NOTICE OF MEETING

The City of Lake Elmo
Planning Commission will conduct a meeting on
Monday August 9, 2021
at 7:00 p.m.

**City of Lake Elmo
Planning Commission Meeting
Minutes of July 26, 2021**

3.32 OF 28

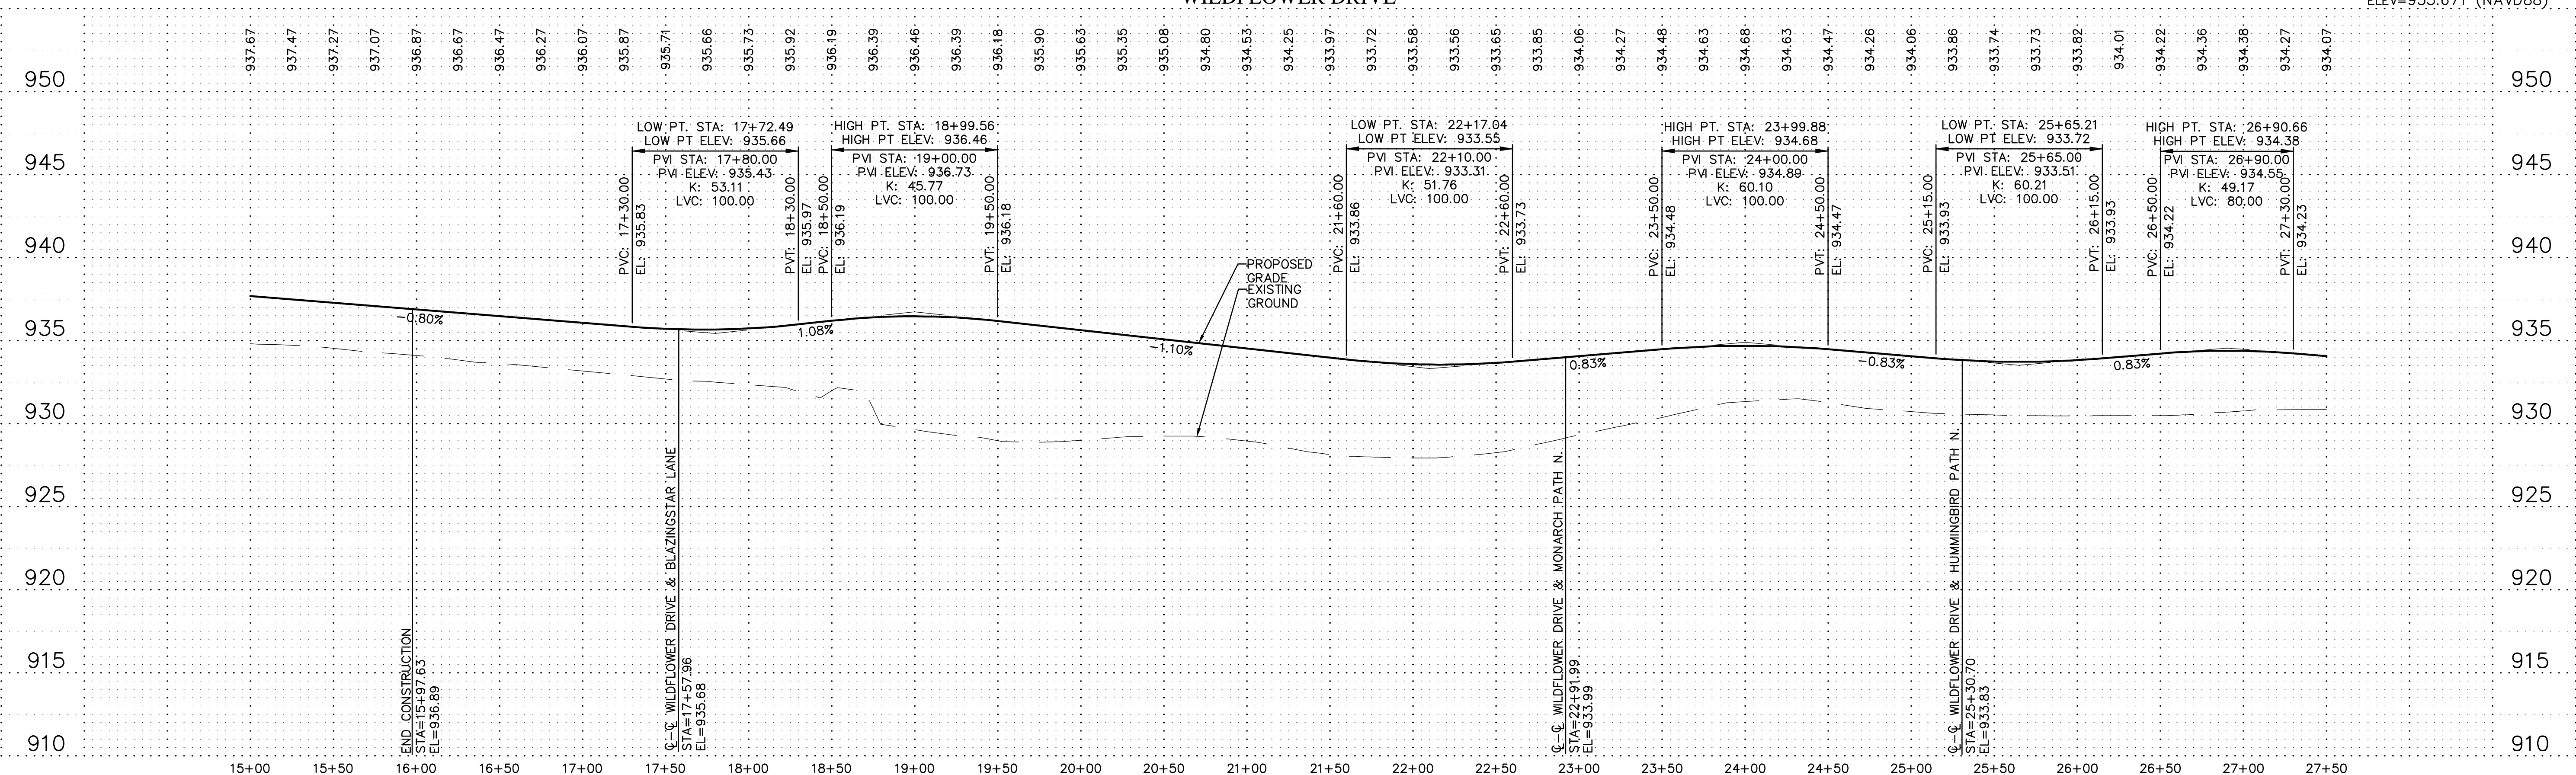
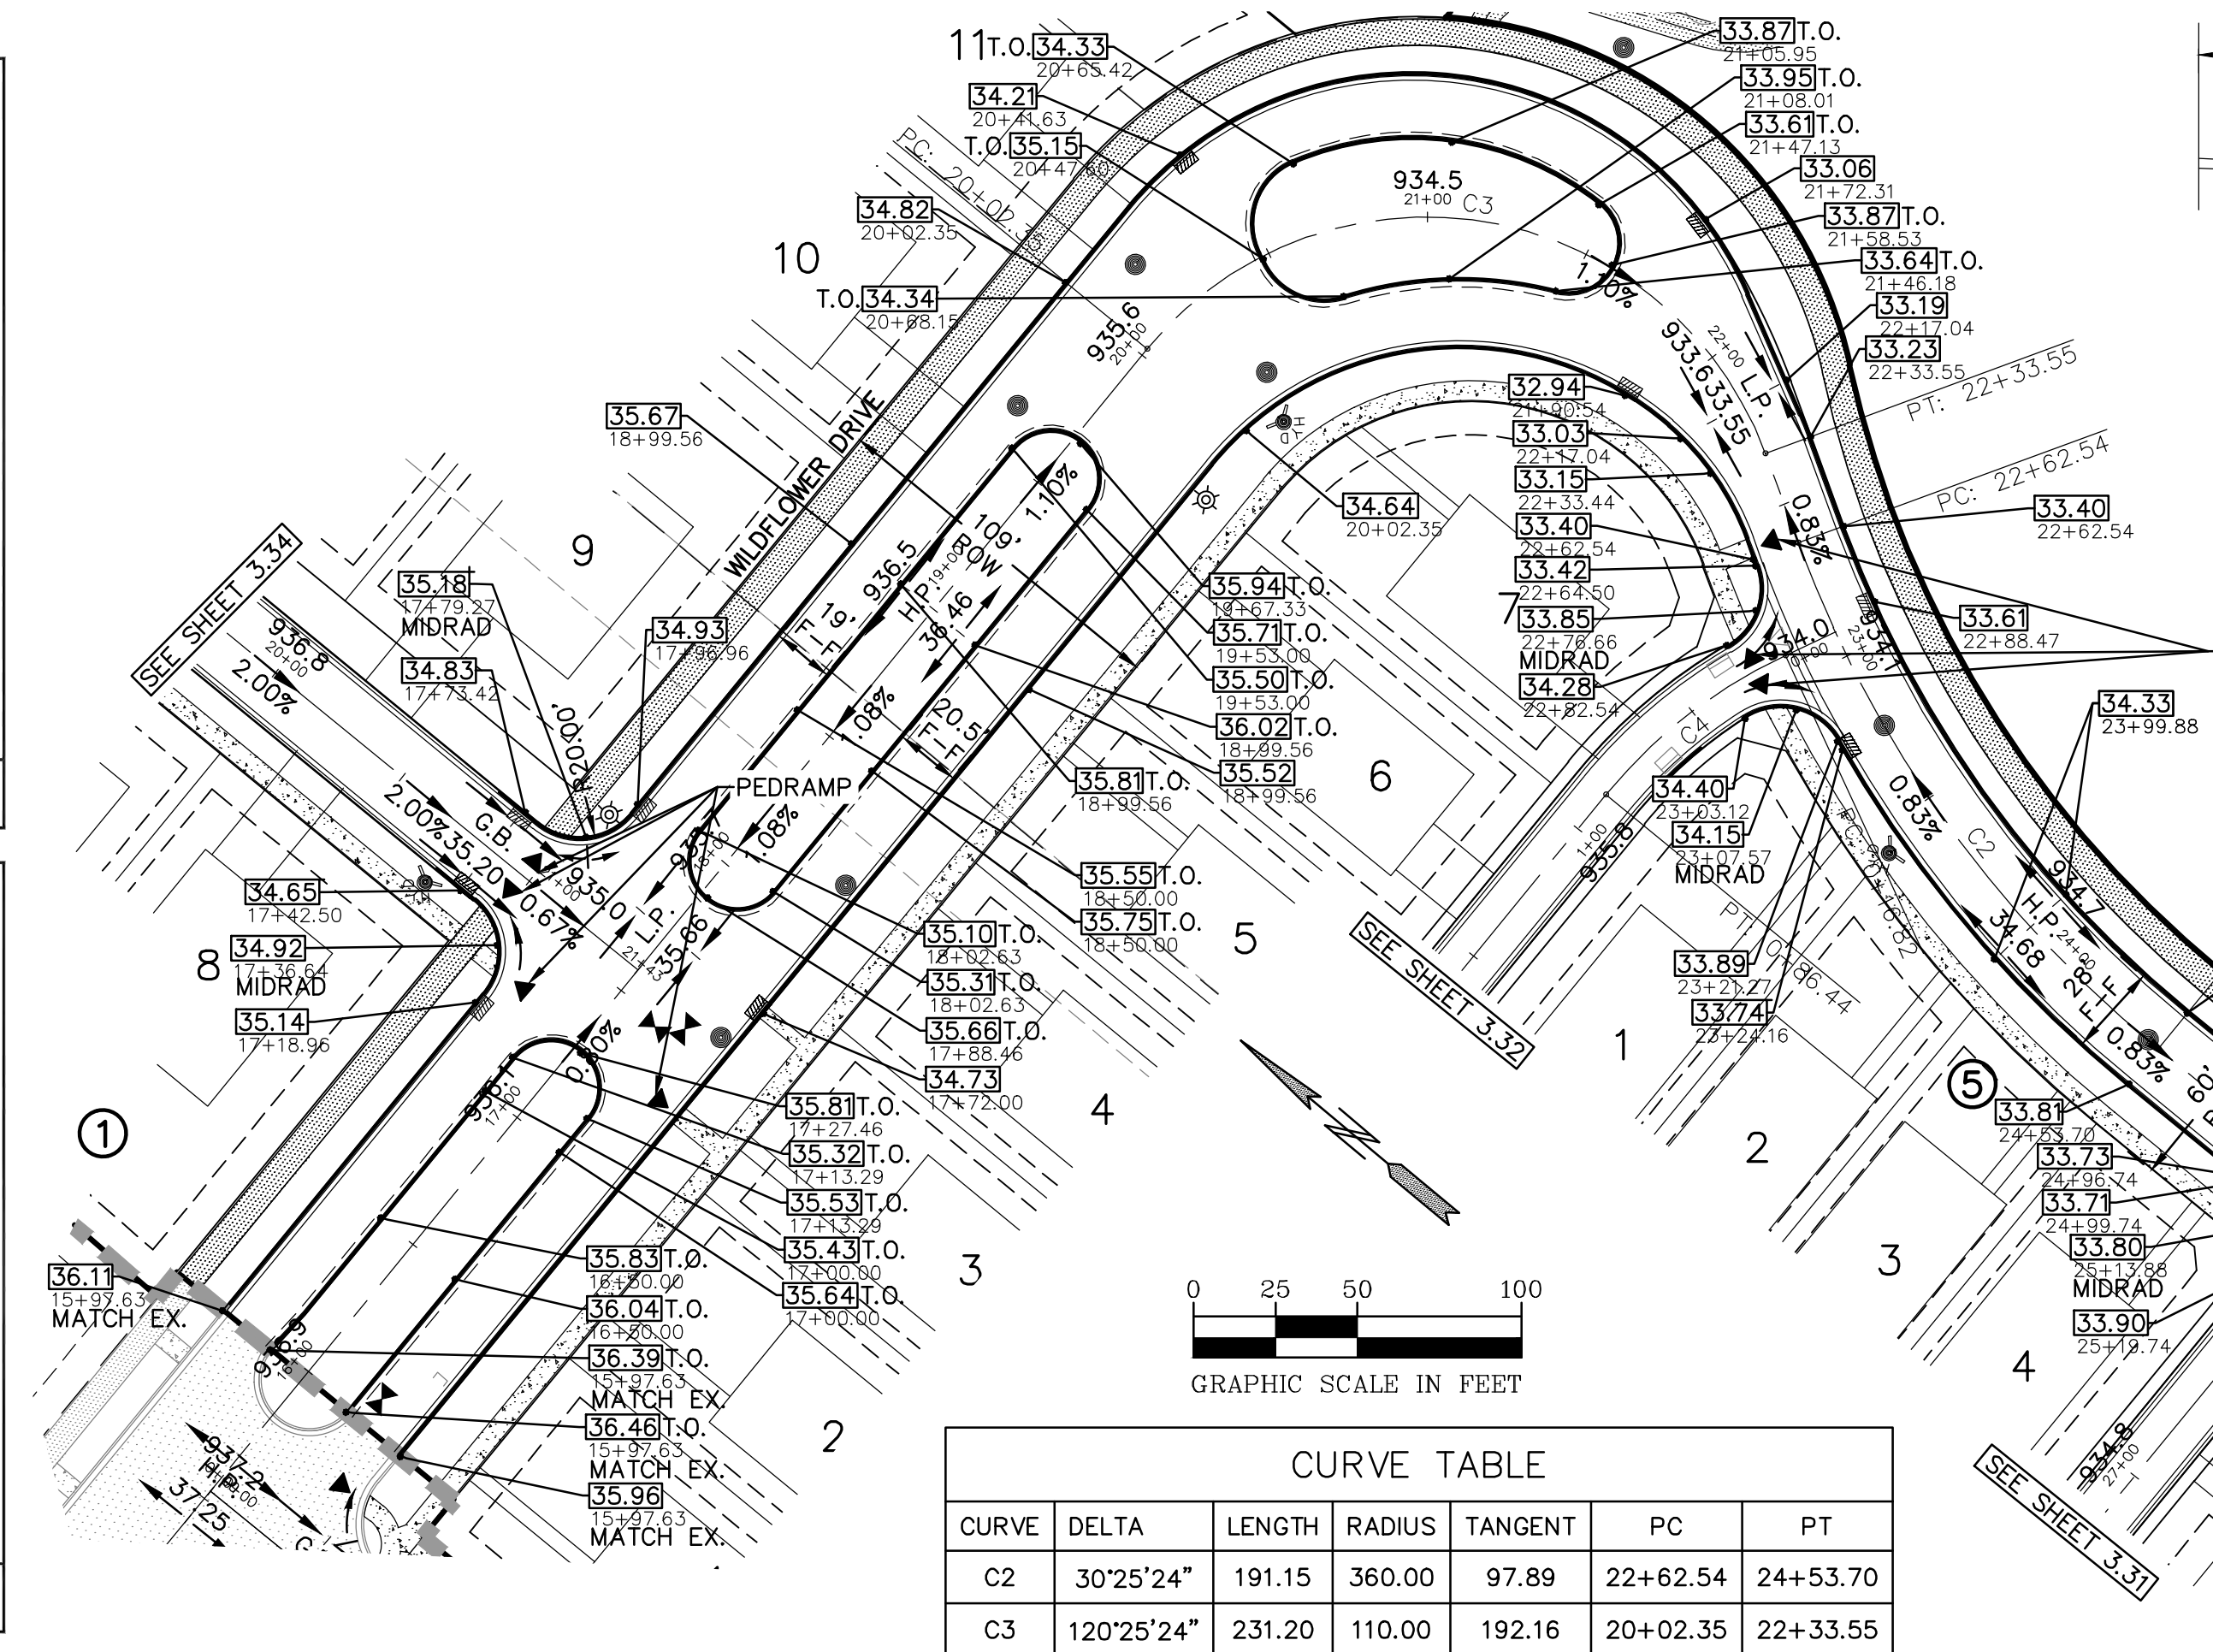
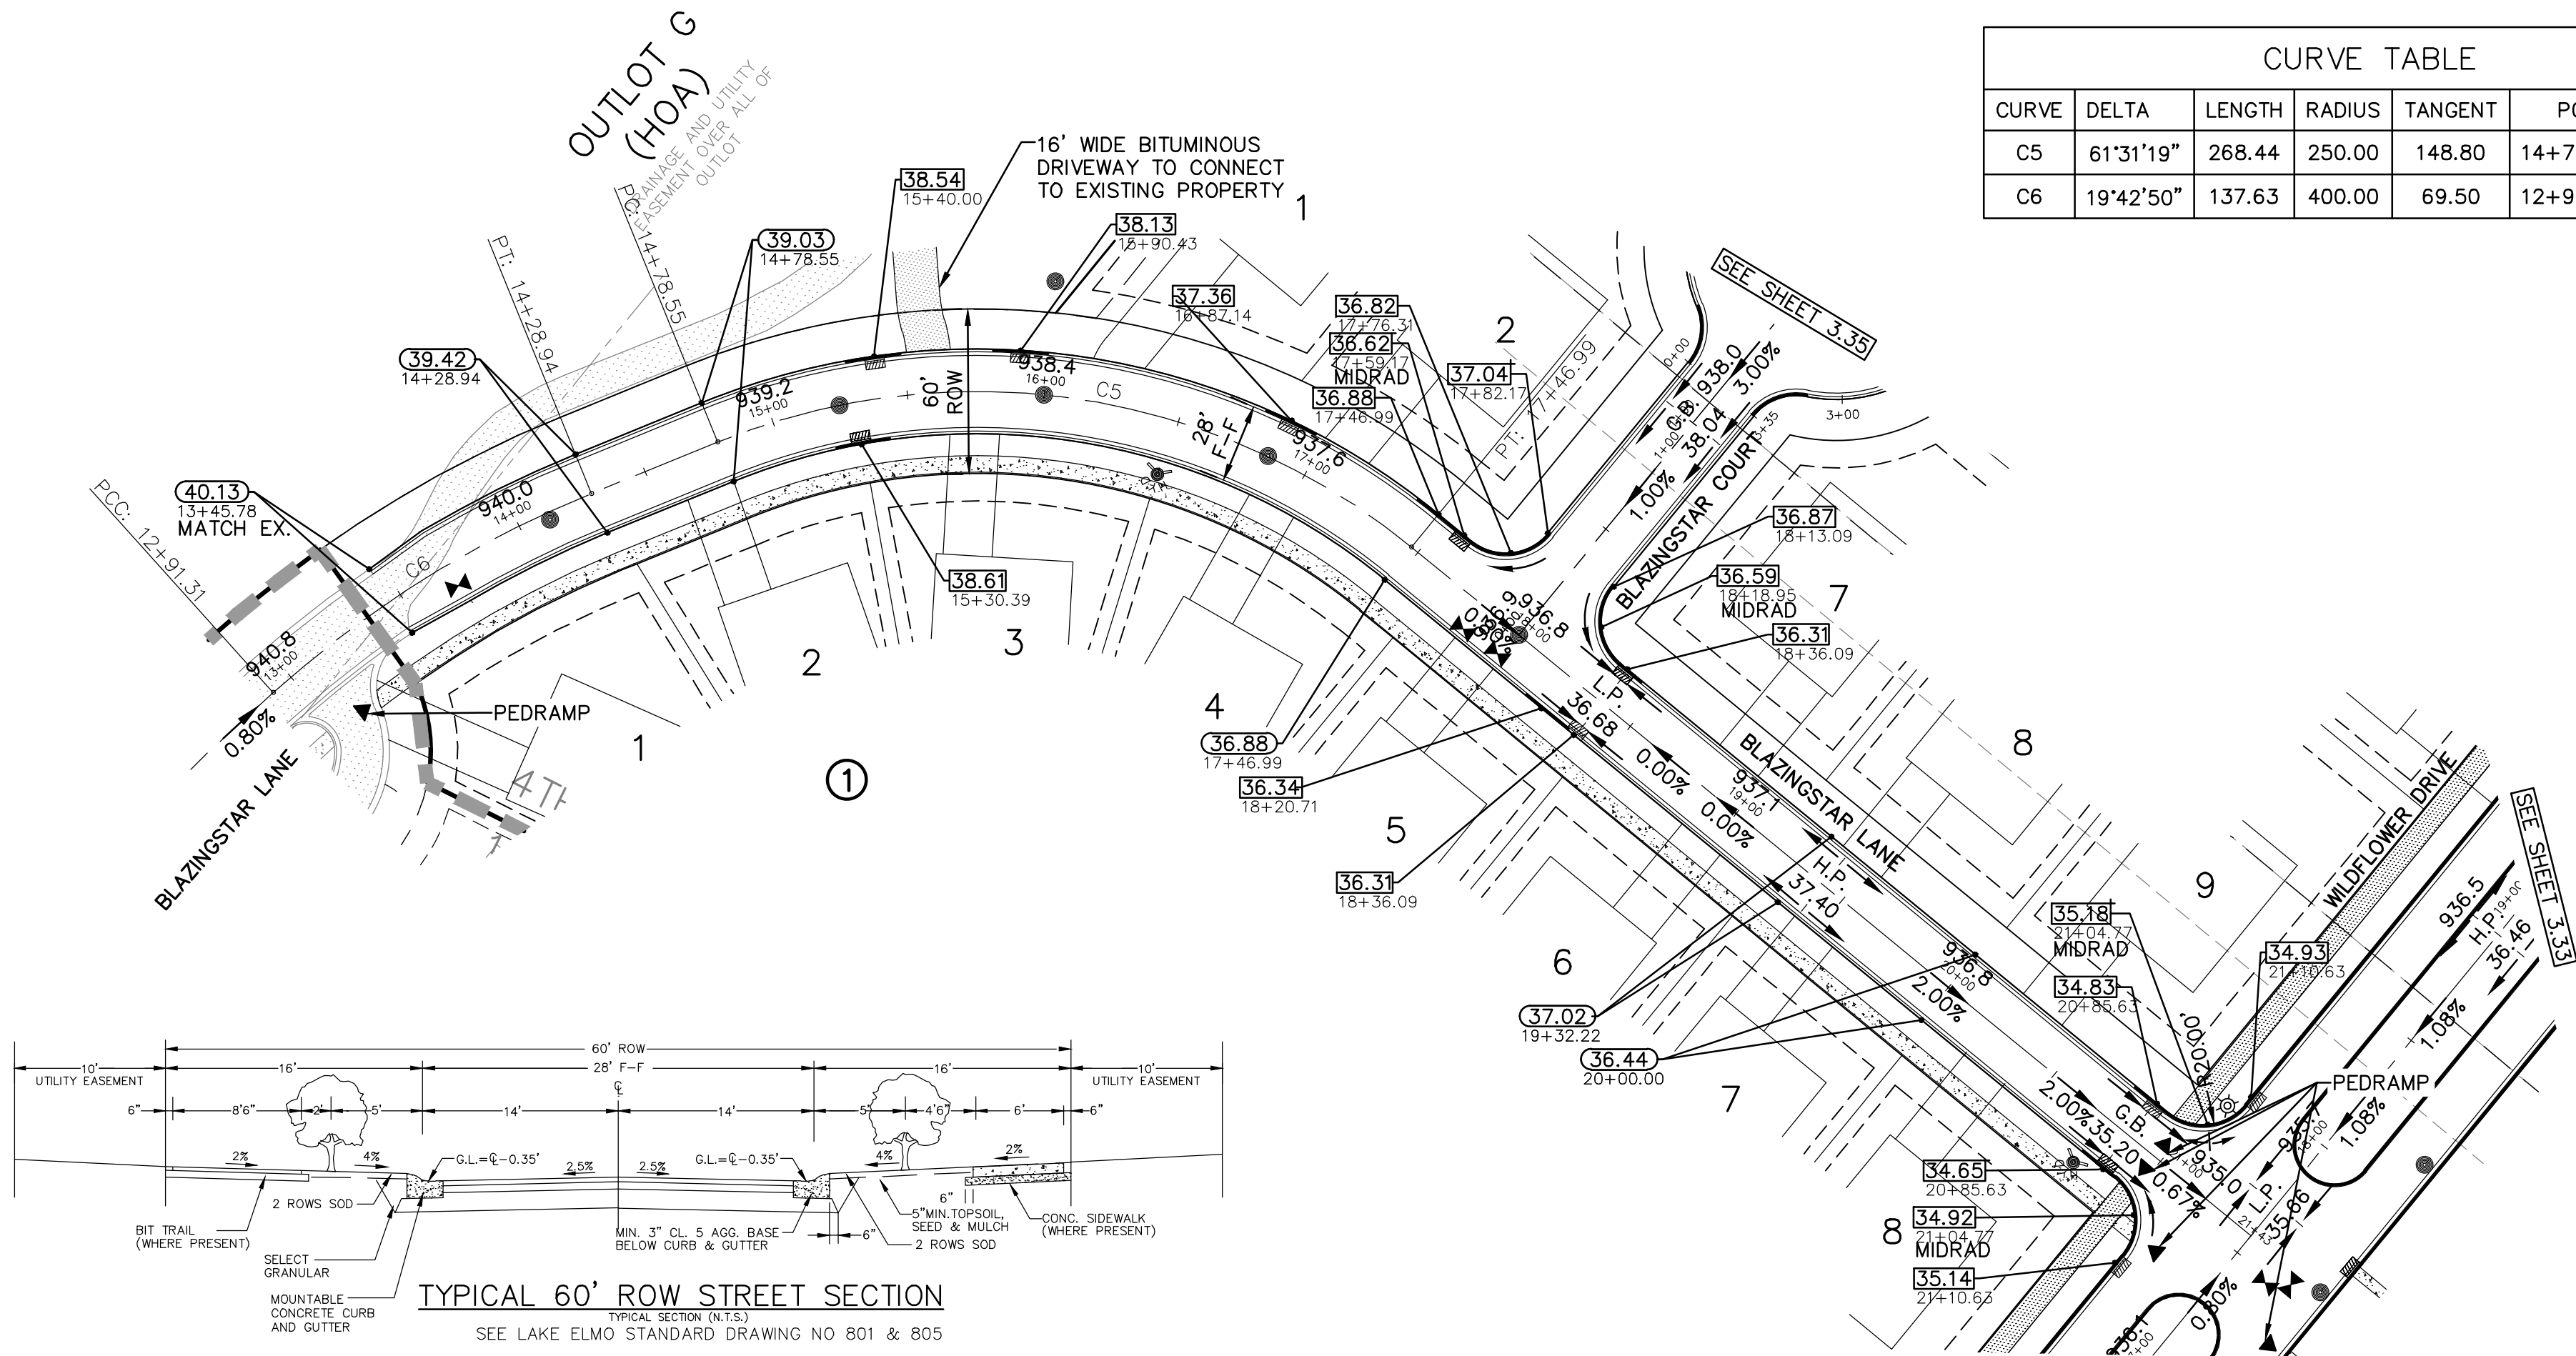
- Sheet 3.31 and 3.32. Revise plan view to show location of sidewalk within the street right-of-way per the proposed typical section.
- Sheet 3.31. Revise typical section for 30'/32' ROW Street to create two separate typical sections and identify all applicable roadways by name to facilitate city review.
